Re: 2400 E Atlantic Ave Pompano Beach, FL

Florida Power and Light Response Letter

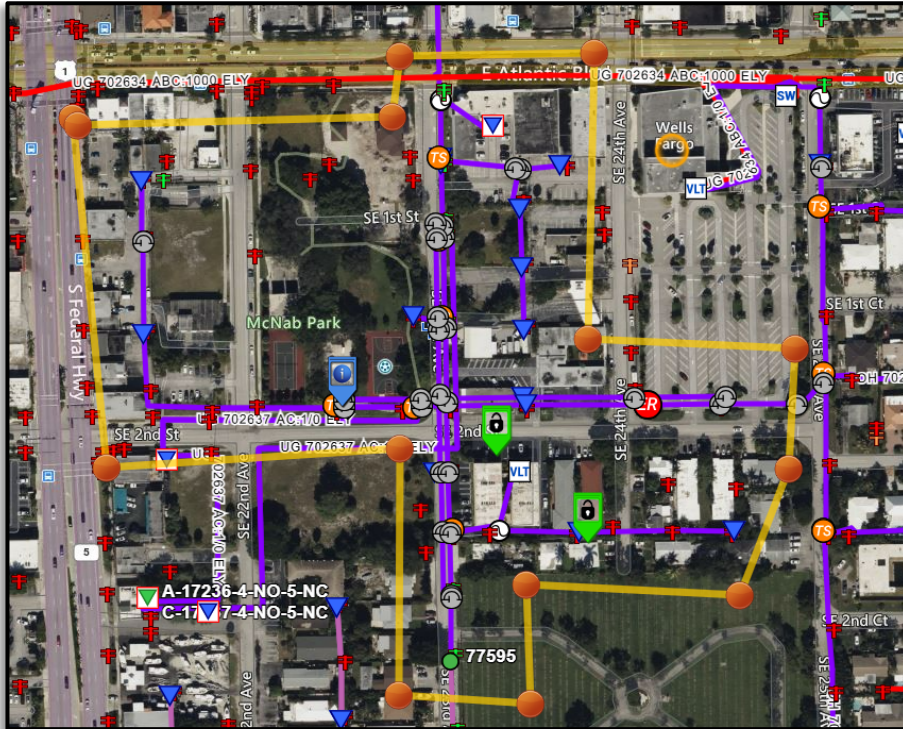
In this situation I would typically provide you an estimate and the requirements for if you did want to move forward with the conversion, however in conversation with my area manager and engineering team the scope for this requirement to be beneficial instead of harmful to the grid far exceeds the 1000 foot requirement [specifically if you are to include the east overhead lines]. To include the overhead lines to the east of the property the scope would need to span everything from E Atlantic Blvd to SE 7th St with all the lines between SE 25th Ave and SE 28th Ave. Your team will also need to confirm the consent of every property owner in that area to the conversion and provide easements for the underground facilities to be installed. Based on our conversation from the site I do not believe this span is directly on the property border so below I will not address it here.

Additionally, while the 1000 foot or 2 block requirement is what we are required to offer for consideration, I would like to point out that the existing facilities on the south of the property heading east along SE 2nd St would likely see a net negative impact on the strength of the grid if converted in the event it is limited to this constraint. I highly doubt that our area management team would approve us from an engineering side to perform the conversion unless it encompasses everything on our feeder 702637 that is south of E Atlantic Blvd between S Federal Hwy and SE 25th Ave as this area is fairly congested with a lot of Automatic Lateral Switches [ALS]. To be clear, ALS are a technology that further works to isolate a fault on our lines by first trying to troubleshoot the fault before opening the fuse. An underground equivalent is currently in the testing phase with our product engineering department, but as it stands now, they are not available for implementation in the field. I cannot say with full confidence that, even with the area outlined in the attached image, the area planning team will be agreeable for this reason.
